Road Safety Audit

Anambah Road, Gosford – Existing Conditions

25.224r01v01

DRAWING TITLE
ANAMBAH ROAD - ROAD SAFETY AUDIT FINDINGS OVERVIEW PLAN

ITEM 2 - CULVERT LOCATION ON STRAIGHT ALIGNMENT (CH2800)

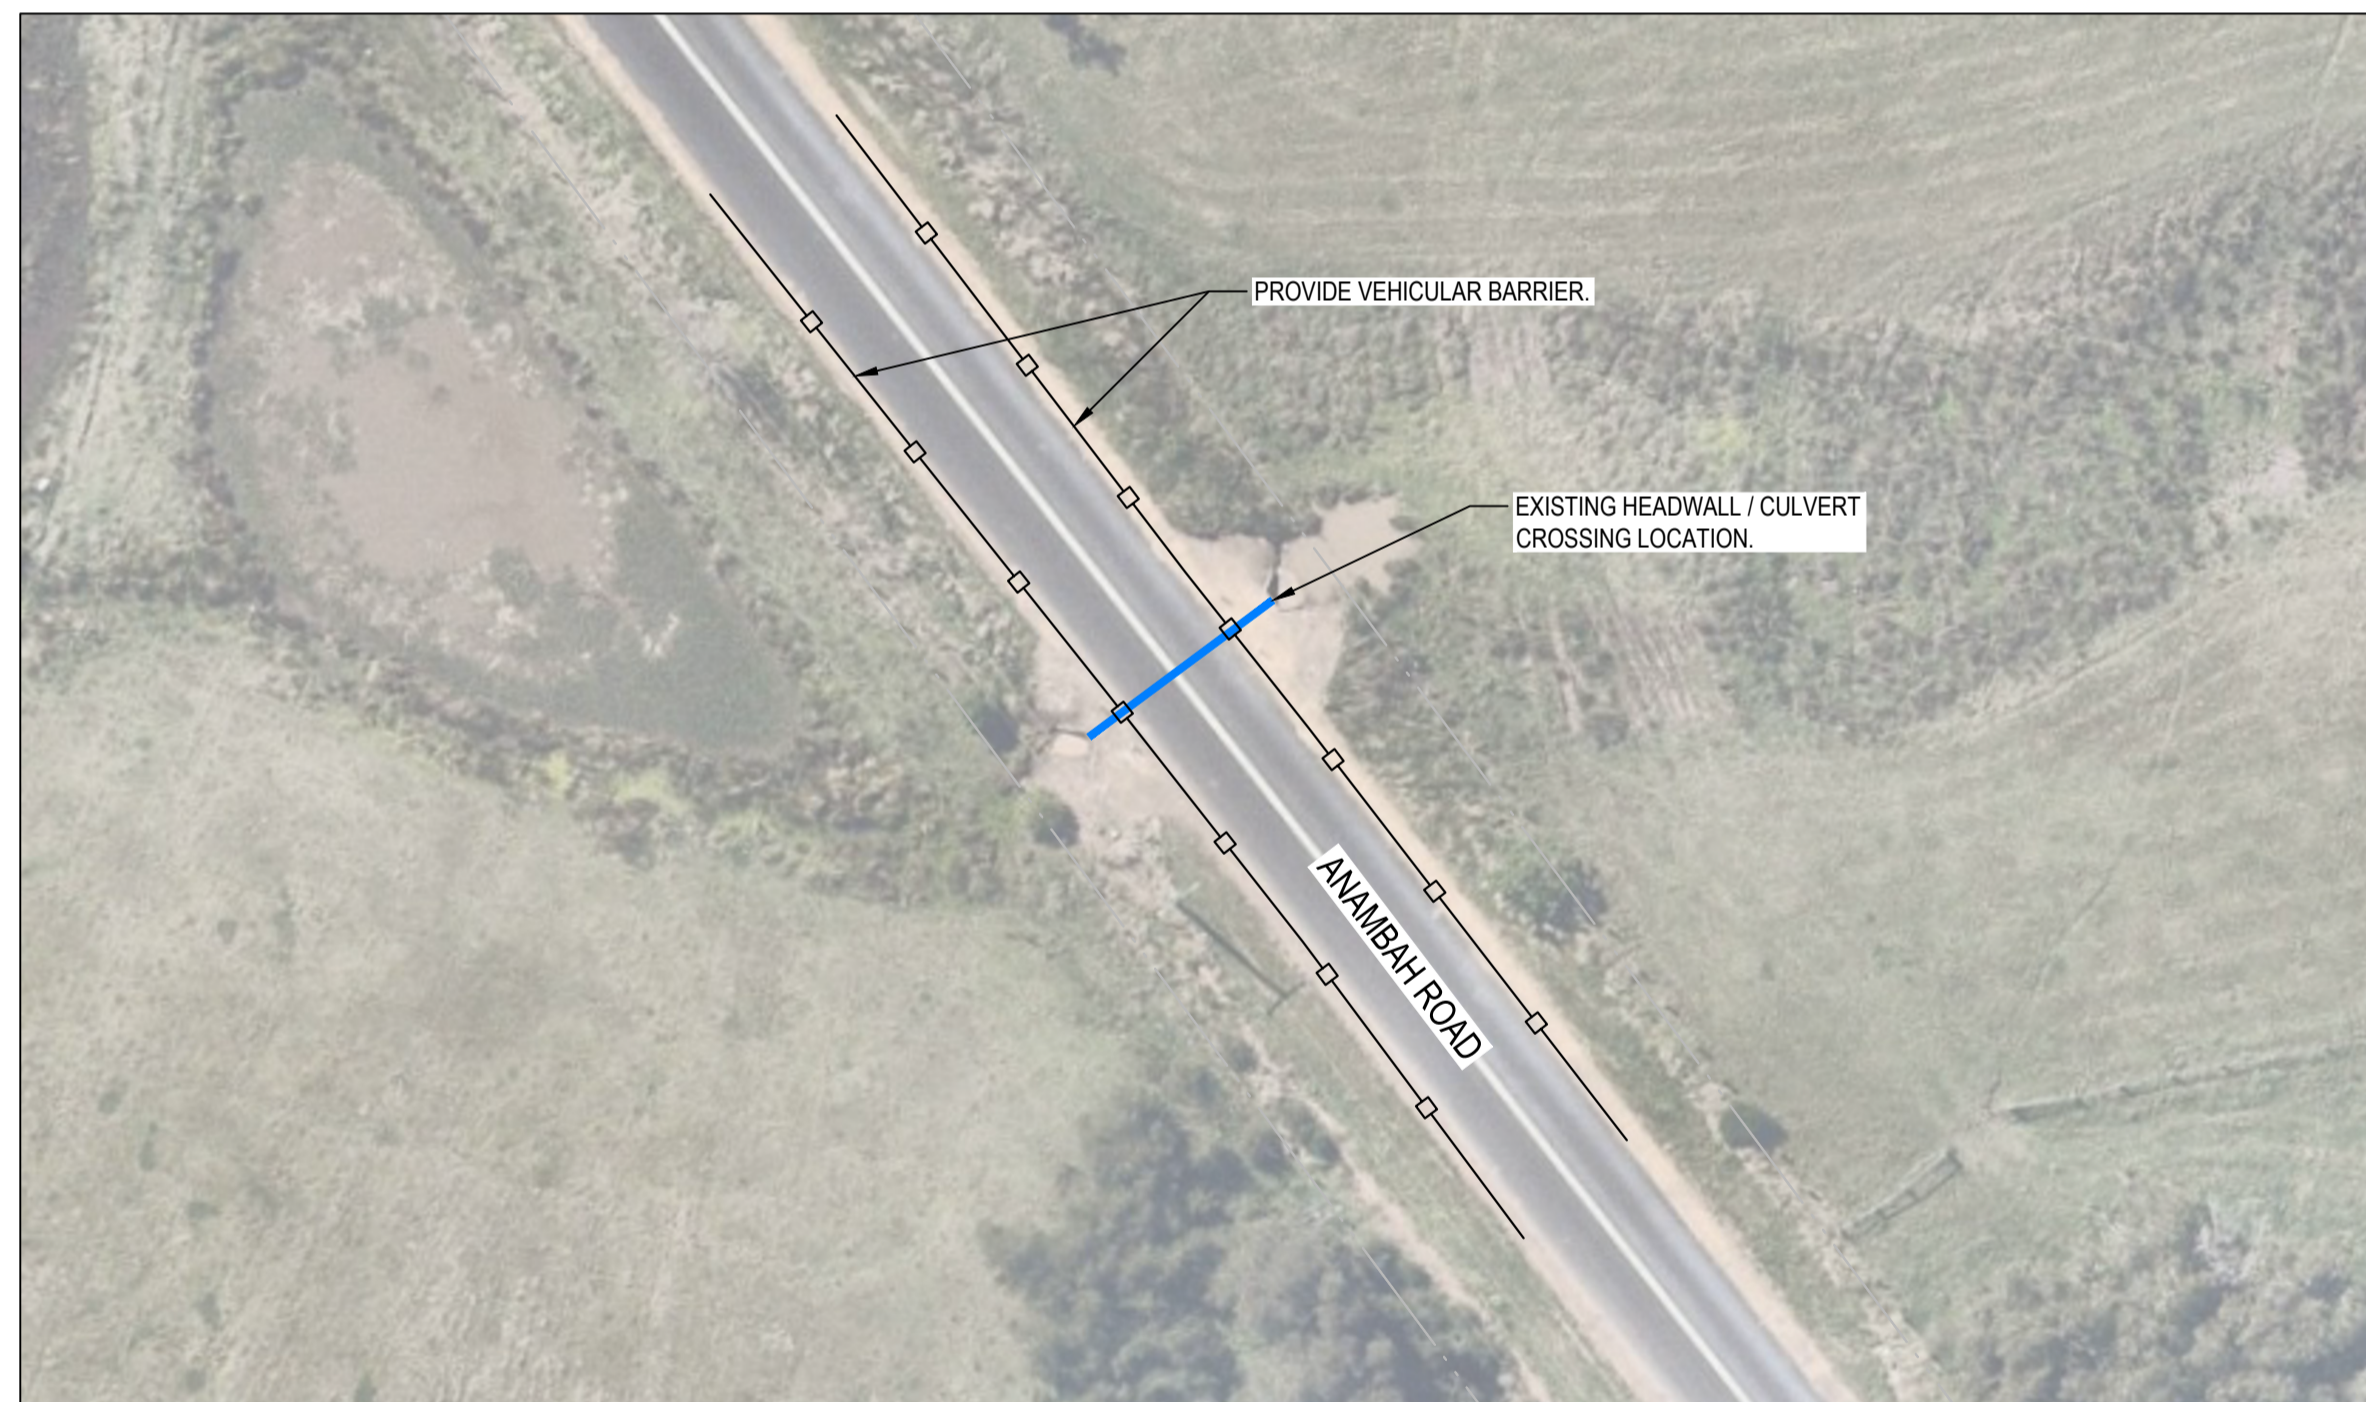
AUDIT FINDING REFERENCE	ROAD SAFETY AUDIT FINDING	LIKELIHOOD	SEVERITY	LEVEL OF RISK	PROJECT MANAGER RESPONSES
2 – Culvert Location on Straight Alignment	<p>There are unprotected culverts / headwalls located within the straight road alignment of Anambah Road. These headwalls present non-frangible hazards in close proximity to the travel lane.</p> <p>There is a risk that errant vehicles in these locations may impact with the headwall, resulting in increased severity of the crash. The likelihood of these locations are considered to be rare given they are on the straight road alignment.</p> <p>These are located at Chainage 1500, 2800, 4400,</p>  <p><i>Example of culvert in close proximity to travel lanes</i></p>	Rare	Serious	Medium (FSI)

ITEM 2 - CULVERT LOCATION ON STRAIGHT ALIGNMENT (CH1500)

ITEM 2 - CULVERT LOCATION ON STRAIGHT ALIGNMENT (CH4400)

AUDIT FINDING REFERENCE	ROAD SAFETY AUDIT FINDING (SEE RSA REPORT PREPARED BY PDC CONSULTANTS FOR FULL DESCRIPTION)	INITIAL RISK (AS IDENTIFIED IN RSA REPORT BY OTHERS)			DESIGN ACTION / REMEDIATION	RESIDUAL RISK			PERSON RESPONSIBLE FOR CONTROLS
		LIKELIHOOD	SEVERITY	LEVEL OF RISK		LIKELIHOOD	SEVERITY	LEVEL OF RISK	
2	CULVERT LOCATION ON STRAIGHT ALIGNMENT (CH1500, CH2800, CH4400)	RARE	SERIOUS	MEDIUM (FSI)	PROVIDE VEHICULAR BARRIER AT CULVERT LOCATIONS	RARE	MODERATE	LOW	DEVELOPER
14	UNPROTECTED EMBANKMENTS	RARE	SERIOUS	MEDIUM (FSI)	PROVIDE VEHICULAR BARRIER AT CULVERT LOCATIONS	RARE	MODERATE	LOW	DEVELOPER

DRAWING TITLE
ANAMBAH ROAD - ROAD SAFETY AUDIT FINDINGS INSET PLAN 04

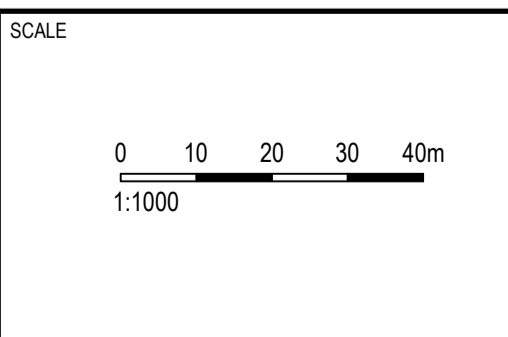
AUDIT FINDING REFERENCE	ROAD SAFETY AUDIT FINDING	LIKELIHOOD	SEVERITY	LEVEL OF RISK	PROJECT MANAGER RESPONSES
7 – Verge vegetation impacts on delineation	<p>There is guardrail located at Chainages 1100 to 1300 that has verge vegetation overgrowth that reduces the visibility of the barrier and its overall delineation, particularly at night and during inclement weather conditions.</p> <p>There is a risk that a driver may be unaware of the roadside conditions and presence of guardrail in close proximity to the travel lane. This may increase the likelihood of inadvertently crashing with the guardrail.</p>	Rare	Minor	Negligible	
8 – Guide post reflectivity	<p>There are numerous guideposts that have been damaged or their reflectivity is non-existent. Poor delineation, particularly where there are no street lights or other supporting delineation features (such as edgelines) provides poor awareness to driveways regarding the road conditions and alignment. There may be a risk that the likelihood of crashes increases due to insufficient delineation resulting from the damage guideposts.</p>	Unlikely	Moderate	Medium

AUDIT FINDING REFERENCE	ROAD SAFETY AUDIT FINDING	LIKELIHOOD	SEVERITY	LEVEL OF RISK	PROJECT MANAGER RESPONSES
10 – Insufficient Acceleration Lane	<p>The vehicular access to the Organics Processing Facility on Anambah Road at approximate Chainage 1200 consists of a channelised right turn for vehicles entering from the south and an acceleration lane for vehicles exiting to the south. On approach to the intersection, a merge lane sign is provided for southbound vehicles to indicate the road conditions at the intersection.</p> <p>Vehicles travelling southbound cannot see the intersection or acceleration lane until approximately 120-metres.</p> <p>Within the 100 km/h zone, there may be insufficient sight distance for southbound vehicles to observe vehicles entering and exiting the Organics Processing Facility, and react to avoid a collision. Furthermore, the acceleration lane appears to be insufficient for the 100 km/h speed zone which may result in abrupt deceleration for vehicles travelling south on Anambah Road resulting in rear-end or run-off road crashes.</p>  <p><i>Southbound view on approach to Organics Processing Facility, approximately 120-metres from intersection. Merge lane located to the left of the power pole not visible.</i></p>	Rare	Moderate	Medium

ITEM 7:
 VERGE VEGETATION IMPACTS ON
 DELINEATION FROM CH1100 - CH1300
 PROVIDE GENERAL VERGE MAINTENANCE
 TO CLEAR UNWANTED VEGETATION

ITEM 10:
 INSUFFICIENT ACCELERATION LANE
 SPEED LIMIT TO BE REDUCED TO 80km/h ALONG
 ANAMBAH ROAD REDUCING RISK OF CONFLICT
 WITH SOUTHBOUND TRAFFIC

AUDIT FINDING REFERENCE	ROAD SAFETY AUDIT FINDING (SEE RSA REPORT PREPARED BY PDC CONSULTANTS FOR FULL DESCRIPTION)	INITIAL RISK (AS IDENTIFIED IN RSA REPORT BY OTHERS)			DESIGN ACTION / REMEDIATION	RESIDUAL RISK			PERSON RESPONSIBLE FOR CONTROLS
		LIKELIHOOD	SEVERITY	LEVEL OF RISK		LIKELIHOOD	SEVERITY	LEVEL OF RISK	
7	VERGE VEGETATION IMPACTS ON DELINEATION	RARE	MINOR	NEGLIGIBLE	GENERAL VERGE MAINTENANCE TO CLEAR UNWANTED VEGETATION	RARE	MINOR	NEGLIGIBLE	DEVELOPER
10	INSUFFICIENT ACCELERATION LANE	RARE	MODERATE	MEDIUM	SPEED LIMIT TO BE REDUCED TO 80km/h ALONG ANAMBAH ROAD REDUCING RISK OF CONFLICT WITH SOUTHBOUND TRAFFIC	RARE	MODERATE	MEDIUM	DEVELOPER
